Product Change Notification

Change Notification #: 119191-00

Change Title: Intel® Server System R1208WFTZSR, PCN 119191-00, Label, Product Design Label and Power Supply update

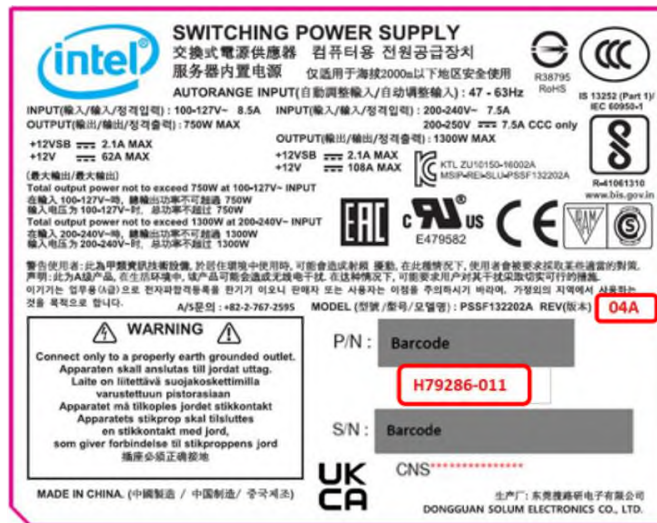
- Adding the UKCA logo in the Server Board Serial Number Label
- The 1300W Power supply is changing from H79286-011 to H79286-012 due to a firmware upgrade from 26.5.128 to 29.5.128 and a minor hardware change, there is no impact on functionality
